## Addendum No. 1

**Subject:** Andrew Hamilton School – Parking Lot Reconstruction and Stormwater Management  
SDP Contract No. 2022-013-G

**Location:** Andrew Hamilton School  
5624 Spruce Street  
Philadelphia, PA 19139

**This Addendum, dated 12th of October, 2022, shall modify and become part of the Contract Documents for the work of this project. Any items not mentioned herein, or affected by, shall be performed strictly in accordance with the original documents.**

DEMOLITION PLAN

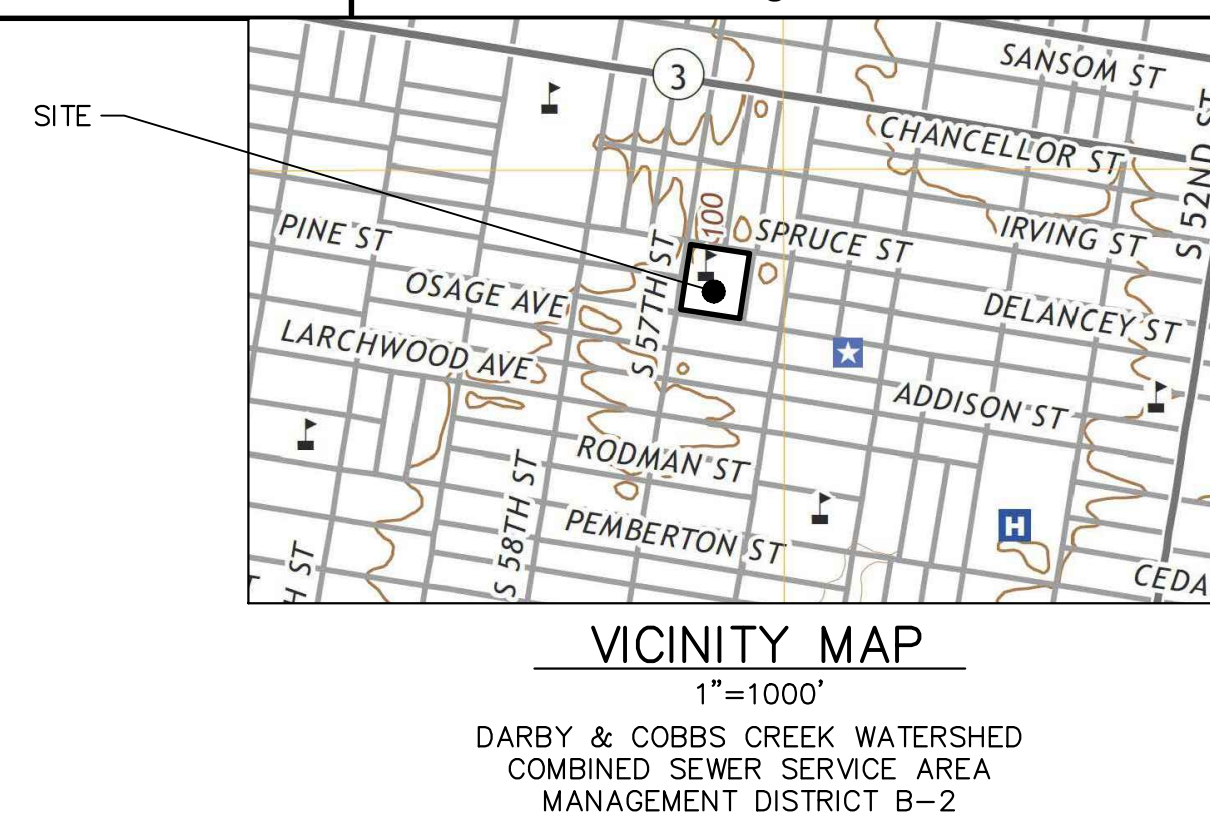
#### **DRAWING C-200 – DEMOLITION PLAN**

1. Revised Bollards as “to be removed”.
2. Revised Demolition area to include steps that are to be removed.

2. Existing bollards at step are they to remain?

**Answer:** The bollards at the steps will be removed. The plan has been updated accordingly.

C-300

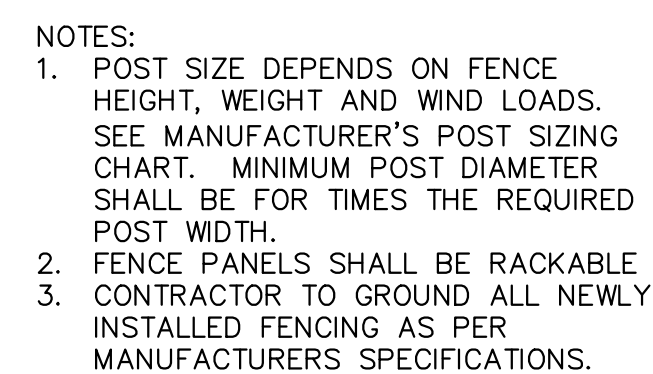
#### **DRAWING C-300 – PROPOSED SITE AND UTILITY PLAN**

1. Revised plan to include the replacement of concrete steps.
2. Revised plan to show the sewer lateral connection at/near the existing Fresh Air Inlet. The new sewer connection will not be needed to be taken to the connection in the street.
3. Added quantity of iron fence to be cleaned.
4. Revised callout to clarify the chain link fence replacement will not be a continuous length of fence but rather total rail length to be replaced.
5. Revised callout to clarify the square footage of brick wall to be repaired.
